BID PACKAGE 01 – ADDENDUM 02

Date: December 10, 2019

Re: Wilma P Mankiller Health Center Expansion

Bid Package 01- Addendum 02 – Wilma P. Mankiller Health Center Expansion

CS101
DEMOLITION PLAN

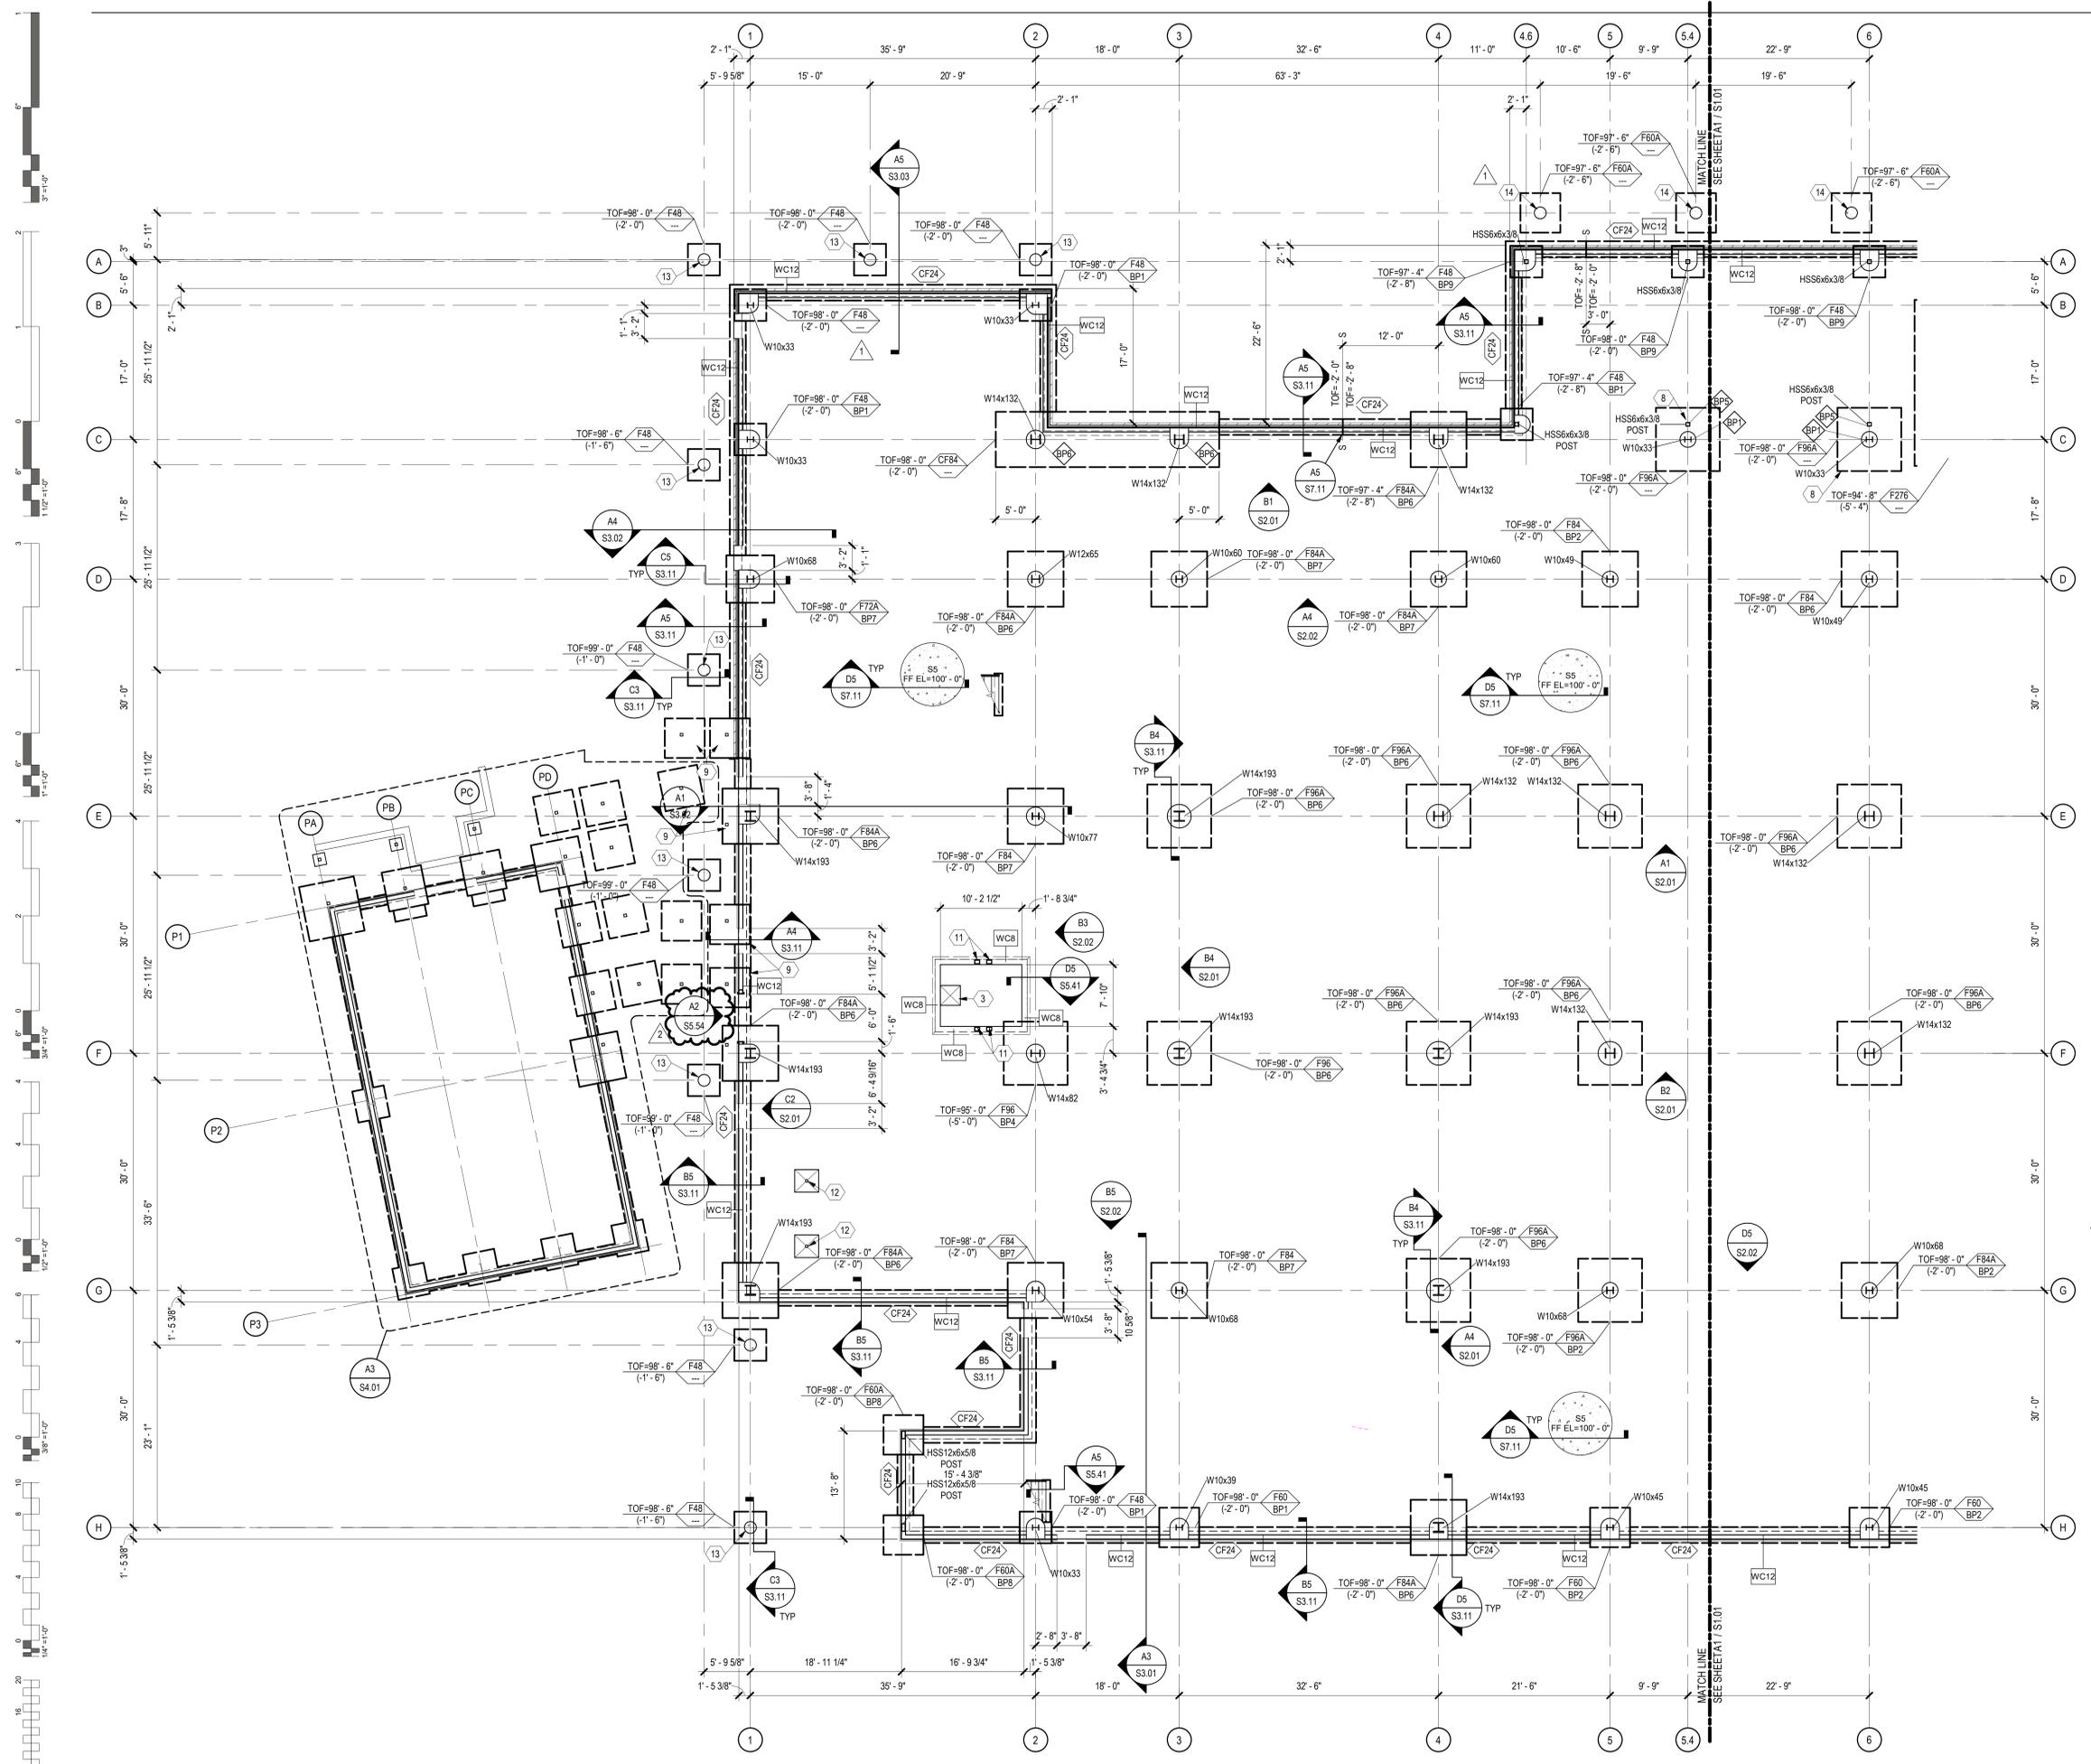
- Item 01** CS101 /CS102 – Existing 8” sewer line and existing 15” RCP storm line north of building needs to be replaced and lowered.
- Item 02** See attached narrative from Chavez Grieves

- 5 UTILITY CUT OFF POINT SYMBOL. THE BEGINNING POINT OF ANY UTILITY (GAS, WATER, SEWER, & ELECTRIC) LINE TO BE REMOVED.
- 6 EXISTING 8" SEWER LINE TO BE REPLACED & LOWERED. RE: FUTURE BID PACKAGE.

- 7 EXISTING 15" Ø RCP PIPE TO BE REPLACED & LOWERED. RE: FUTURE BID PACKAGE.

SHEET NUMBER: S1.02

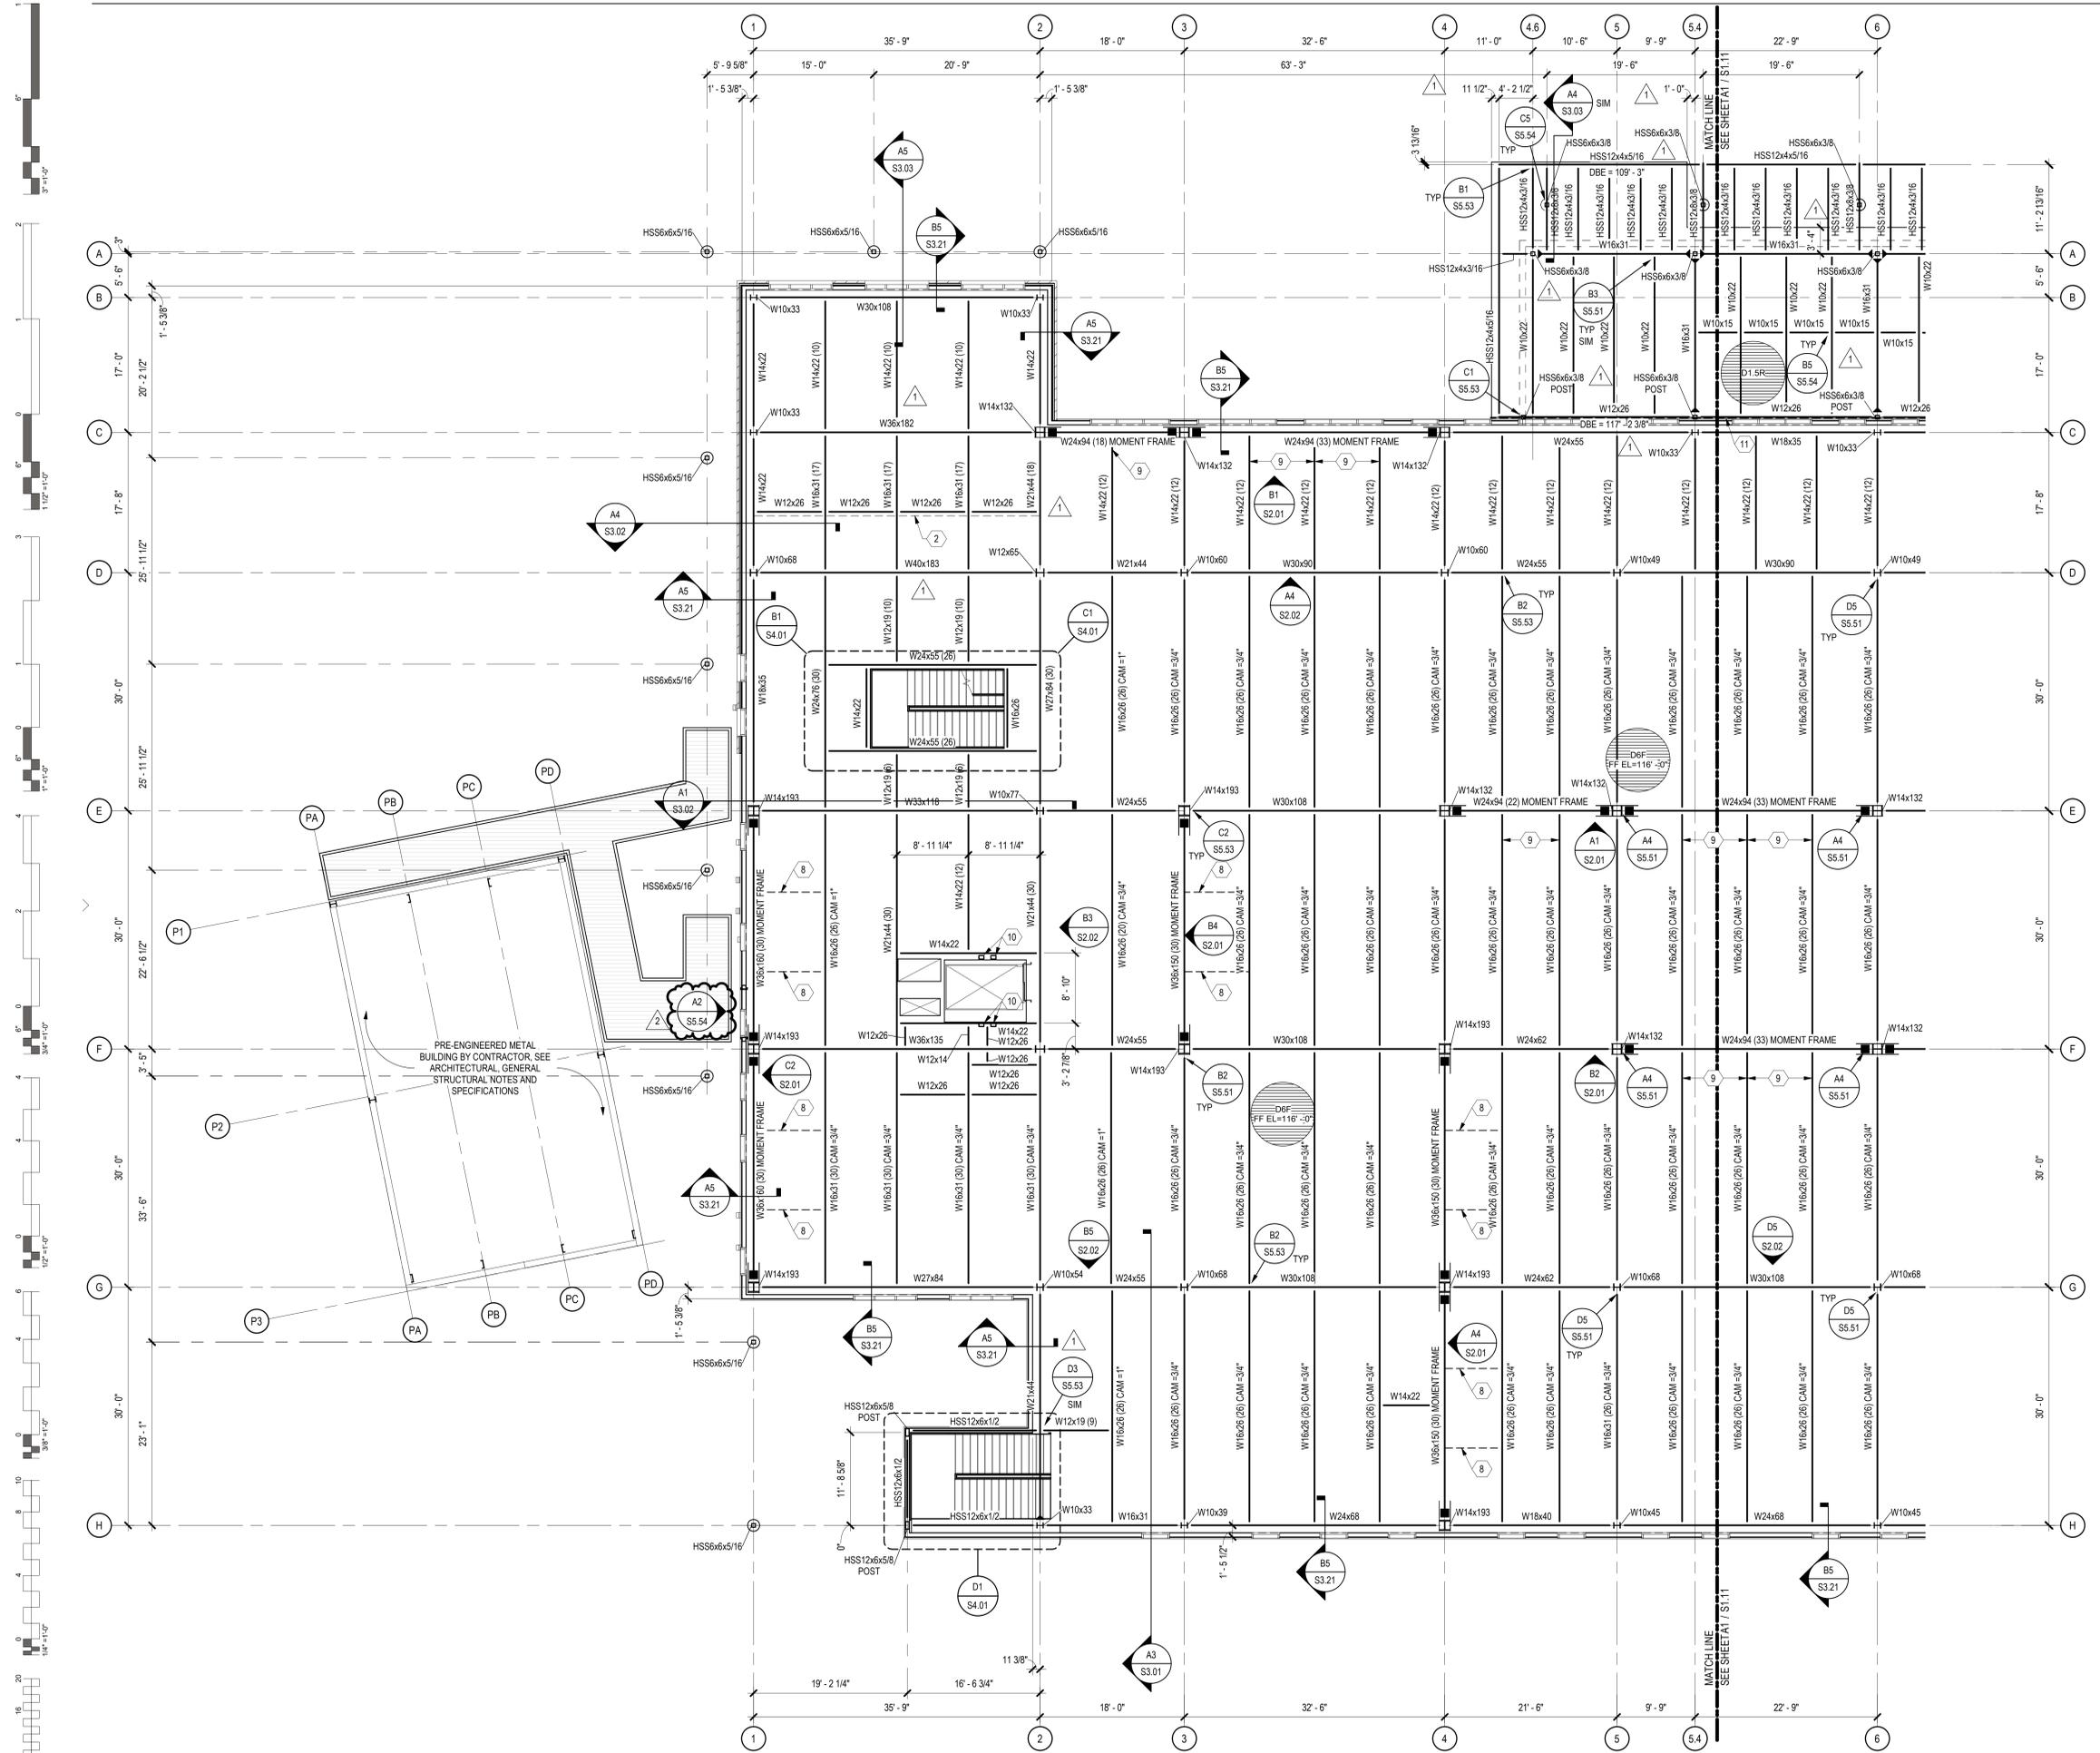
<u>Sheet</u>	<u>Description</u>
S1.02	Rolling door support elevation added near Grid F/1.
S1.12	Rolling door support elevation added near Grid F/1.
S1.13	Stair landing framing adjusted to meet architectural requirements; near Grid E/2. Dimensions added.
S1.21	Sheet keynote 8 added and located on plan.
S1.21	Connection details revised along Grid G, D, and C.
S1.21	Beam sizes near Grid G/8 revised.
S1.21	Bottom flange braces added to beams along Grid G, D and C labeled as "Collector".
S1.22	Sheet keynote 8 added and located on plan.
S1.22	Connection details revised along Grid H, G, and D.
S1.22	Beam size near Grid H/3 revised.
S1.22	Bottom flange braces added to beams along Grid H, G and D labeled as "Collector".
S2.02	Elevations B3 and D4 revised
S3.11	Section D2 revised.
S3.12	Section A3, B3, and D4 added.
S4.01	Plans A3, D2, and D4 revised.
S5.54	Details A2 and B4 added.
S7.41	Detail C2 revised.
